Mixed-Use Development
2 Mark Street & 1-3 Marsden Street, Lidcombe NSW 2141

Development Application

to approved DA 2022 / 0253

DA - B	DRAWINGS UPDATED IN RESPONSE TO DEAP MEETING & COUNCIL RFI (June 2025)	19/08/2025	YT	AHM
DA - A	ISSUED FOR DEVELOPMENT APPLICATION	17/02/2025	YT	AHM
DA - P.3	ISSUED FOR DEAP MEETING	18/06/2024	YT	AHM
ISSUE	AMENDMENT	DATE	DRAWN	CHECKED
Drawing is NOT VALID or issued for use, unless checked.

SHEET TITLE:
Basement 1 Plan

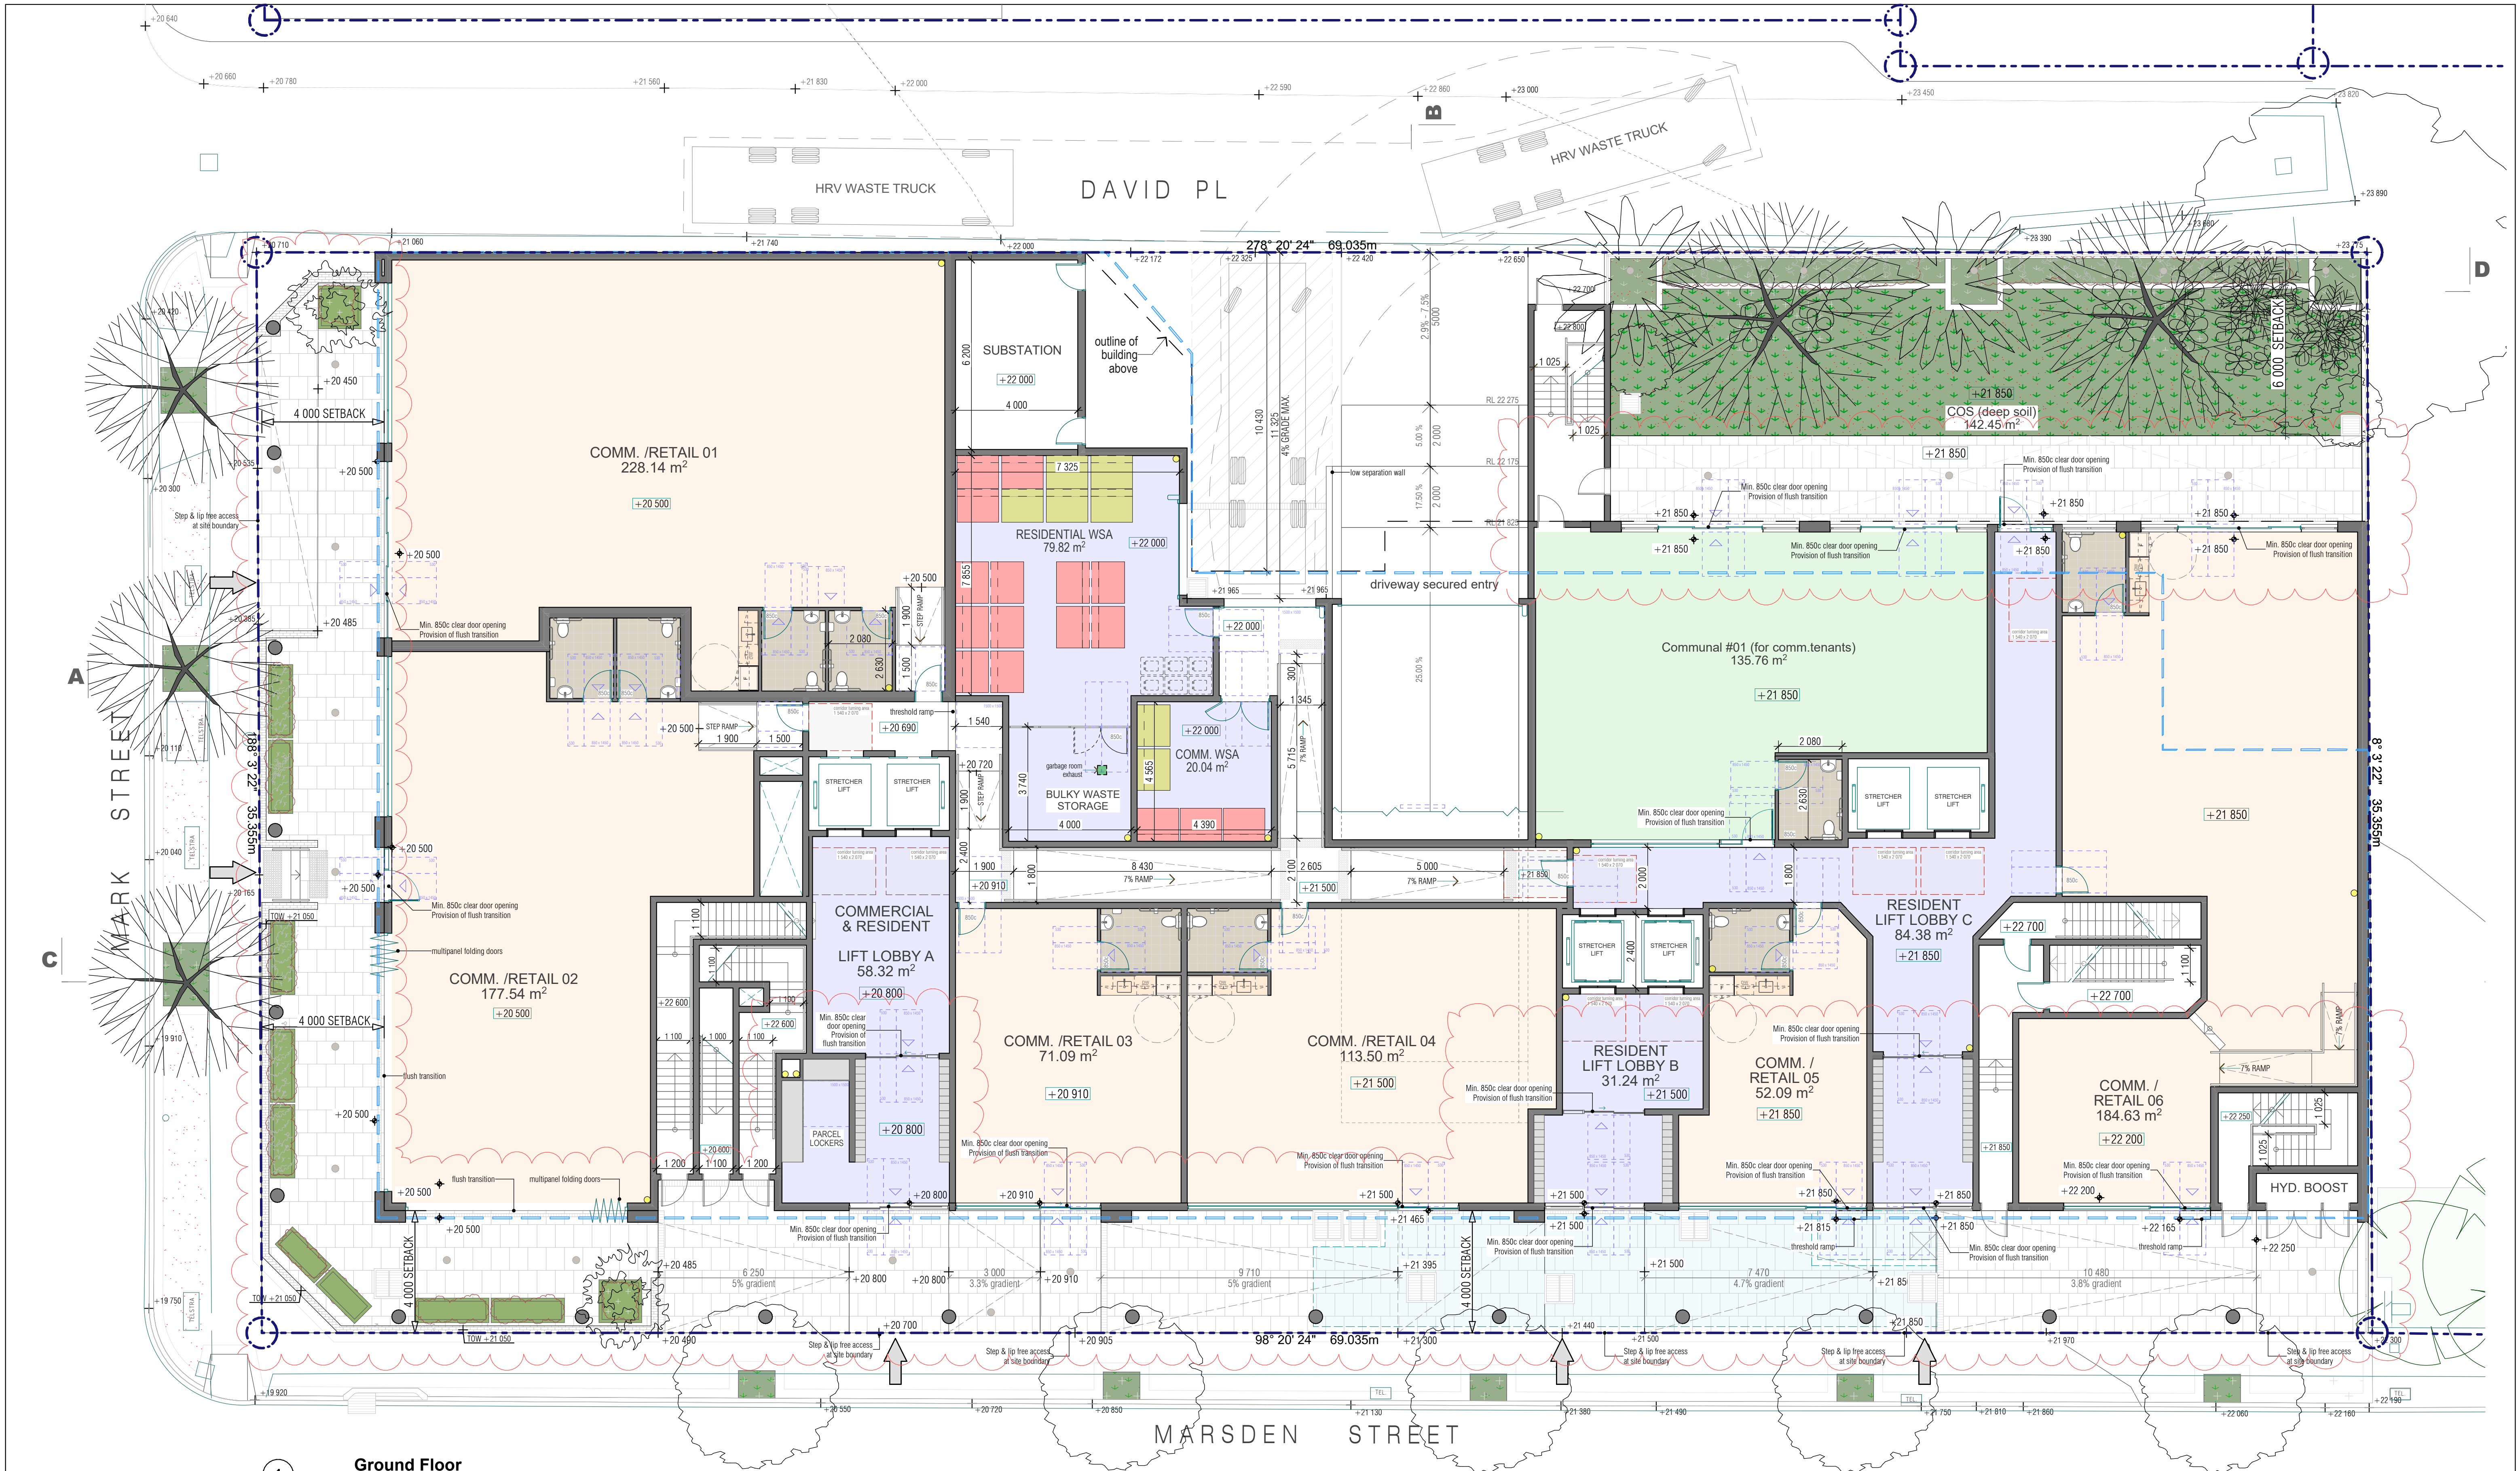
- Firestairs at south easter corner relocated/pushed back. Parking layout & pump room adjusted to suit
- Car parking depth updated to 5.6m
- Secured cage provided for bicycle storage
- Restricted/secured roller door to B2 & B3 now provided to replace the prev boomgate

SHEET TITLE:
Level 4 Plan - BOARDING

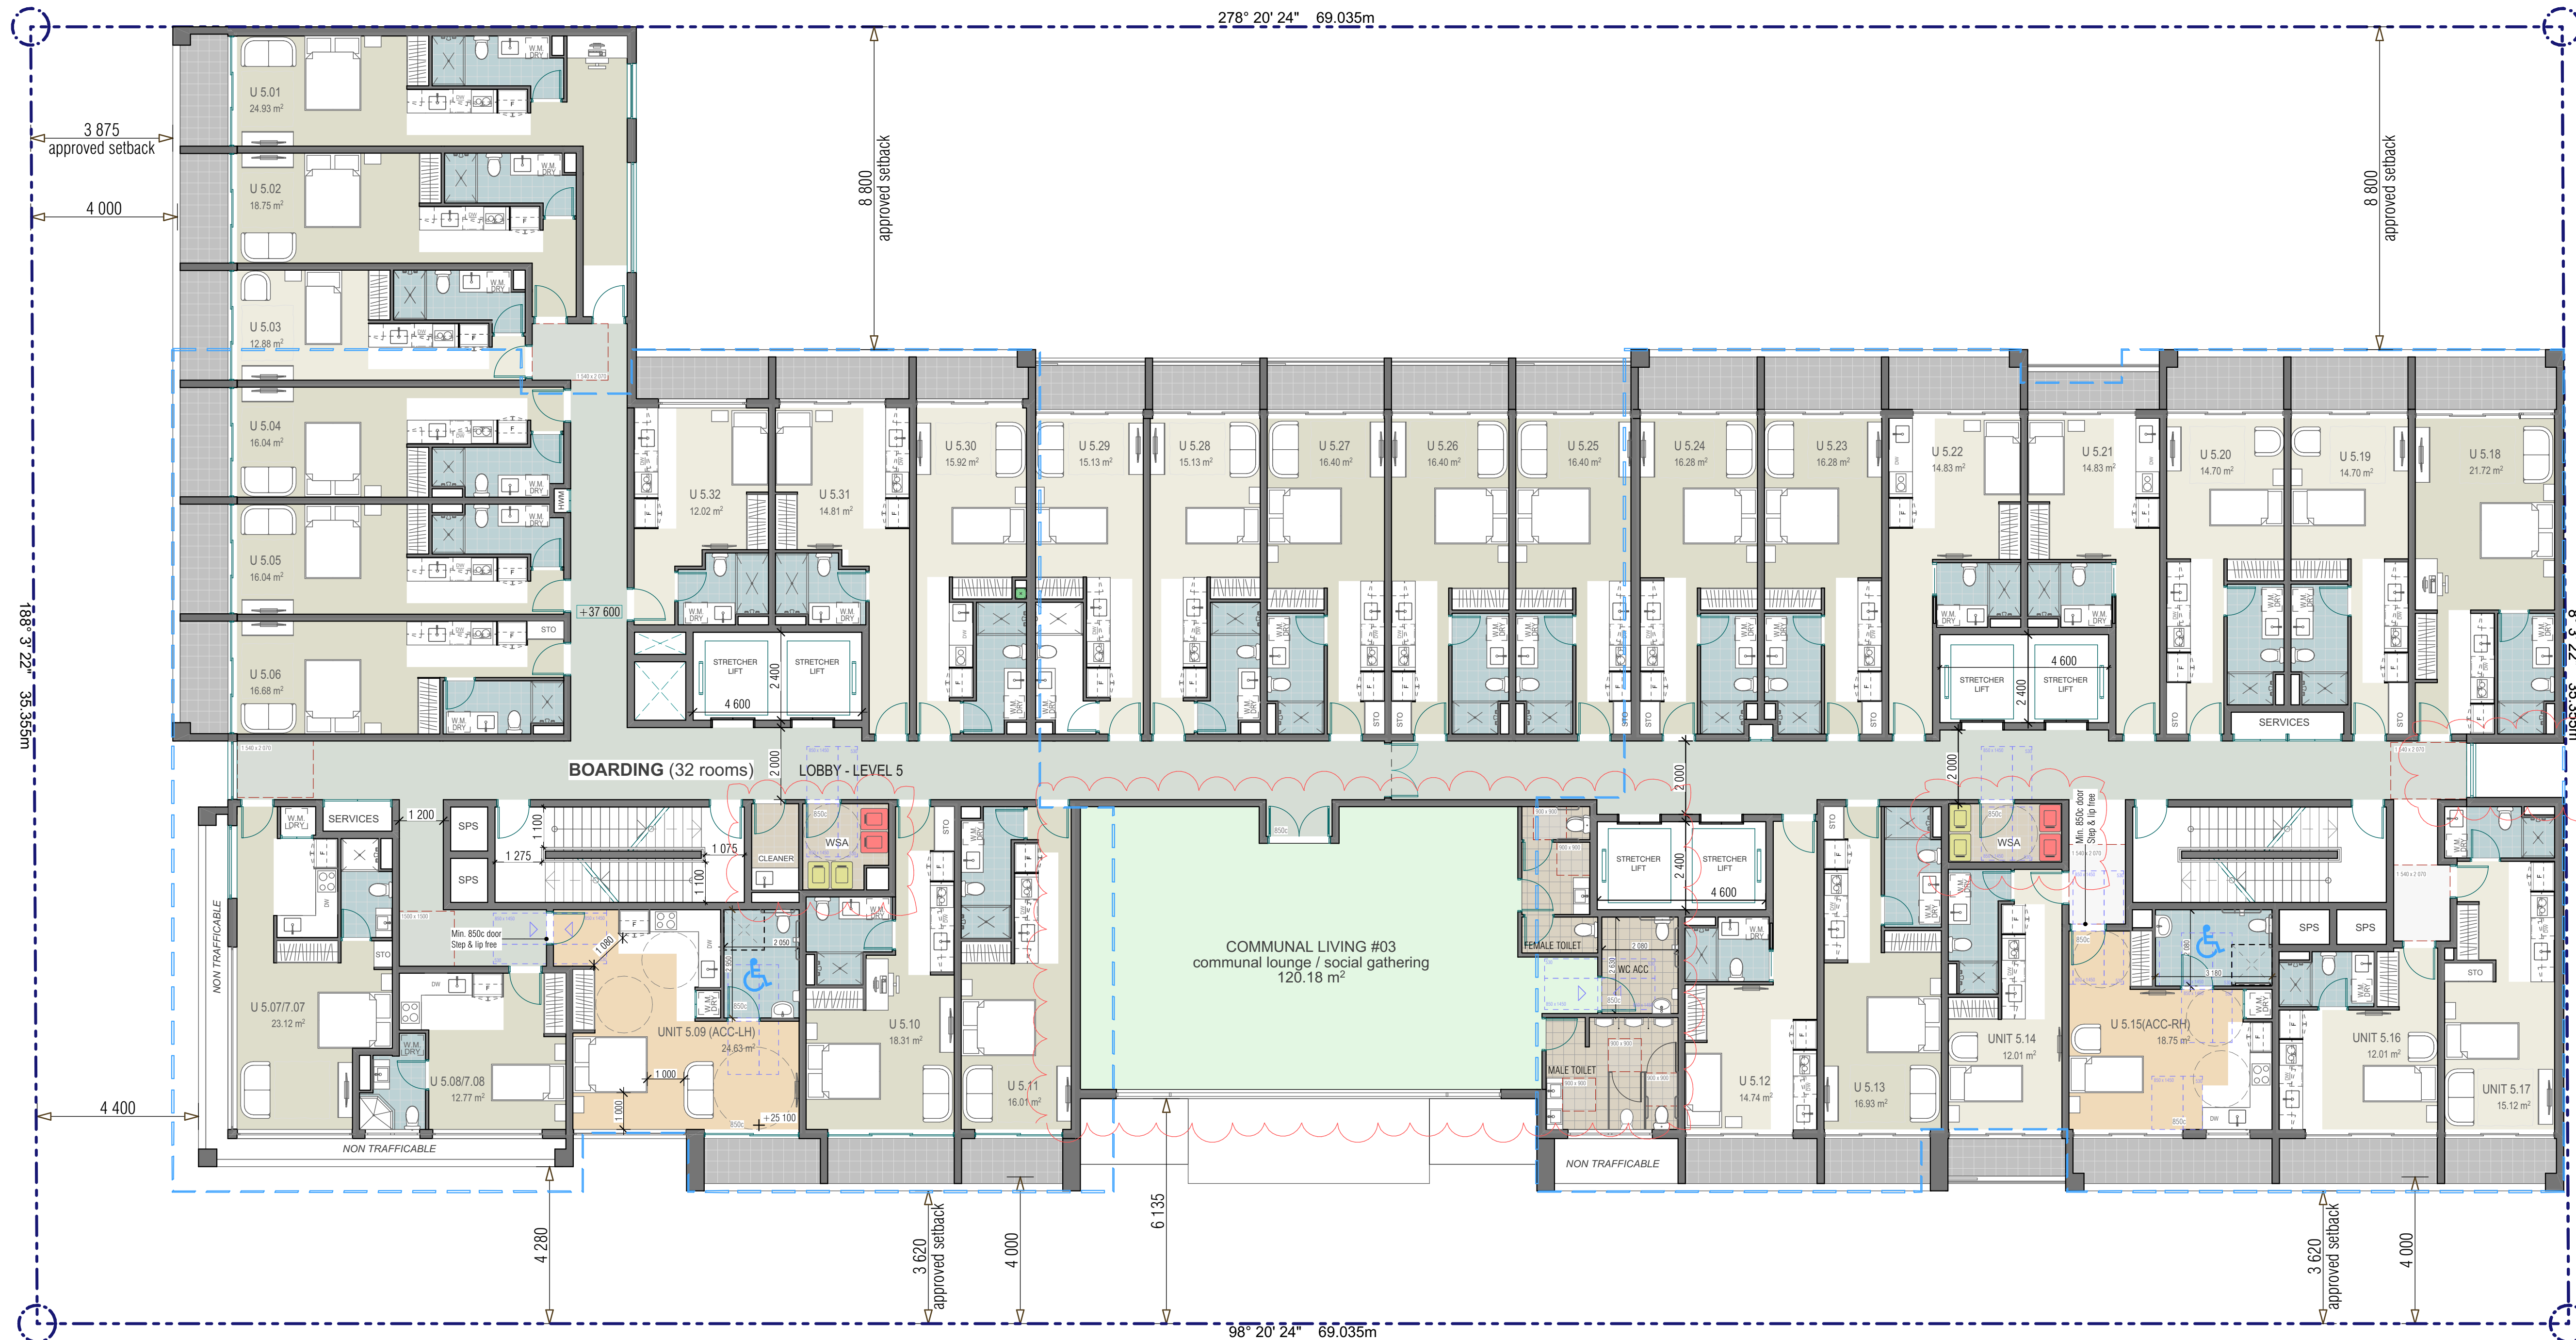
- Temporary bin cupboards relocated to minimise odour impact to residential entries
- Balconies added to unit 4.12-4.15
- Natural light into hallway provided to eastern side of building, adding passive surveillance over nearby park
- Fire separation doors provided within the corridor, fire egress travel distance reduced; as reviewed by BCA consultant
- Communal living #03 (previously on level 4) relocated to level 5. Middle section infilled with residential component
- Unit 4.07 nominated as manager room for boarding house component

SHEET TITLE:
Level 6-7 Plans (Typ.) - BOARDING
DESIGNED: AHM DRAWN: Y T COMPLETED: April 2024
SCALE: 1:100@A1 1:200@A3 or as noted
PRINT: A1 SHEET A3 SHEET
PLOT: Monday, 11 August 2025 3:26 pm
L.G.A: Cumberland Council

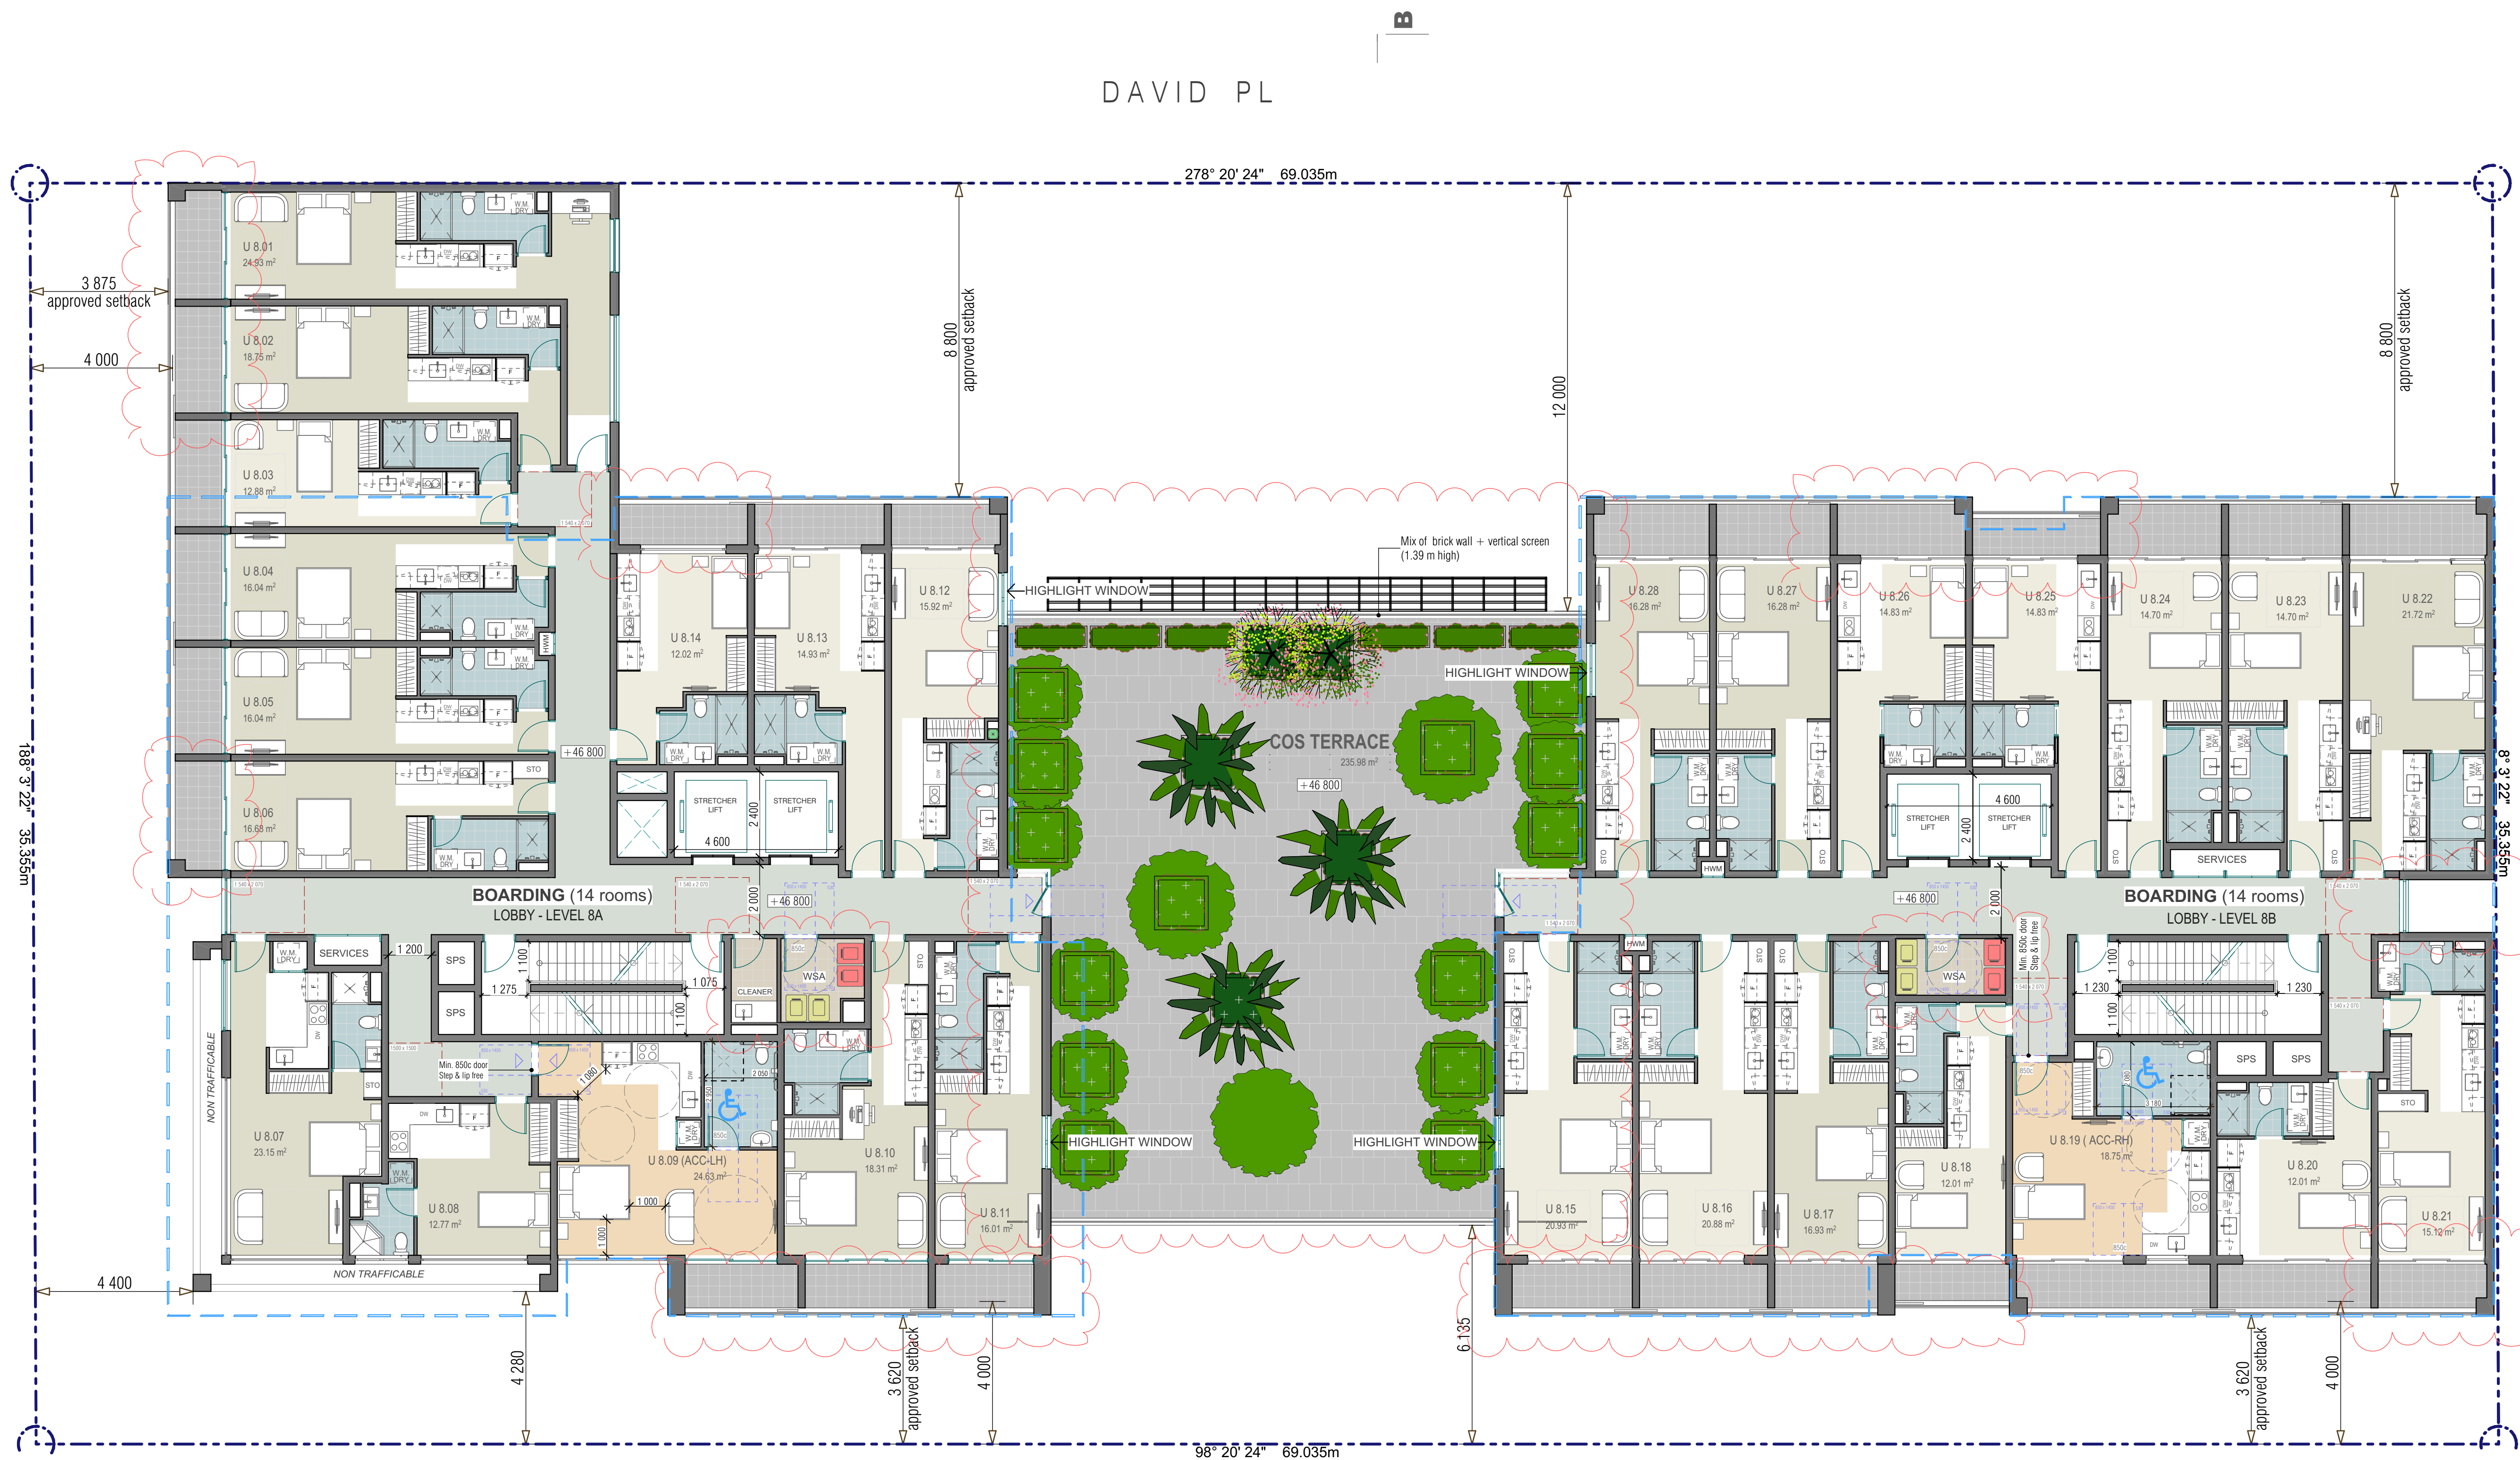
- Temporary bin cupboards relocated to minimise odour impact to residential entries
- Natural light into hallway provided to eastern side of building, adding passive surveillance over nearby park
- Communal living #03-05 (previously on level 4-6) now relocated on level 5-7, area updated
- Balcony added to the clouded units to improve amenity
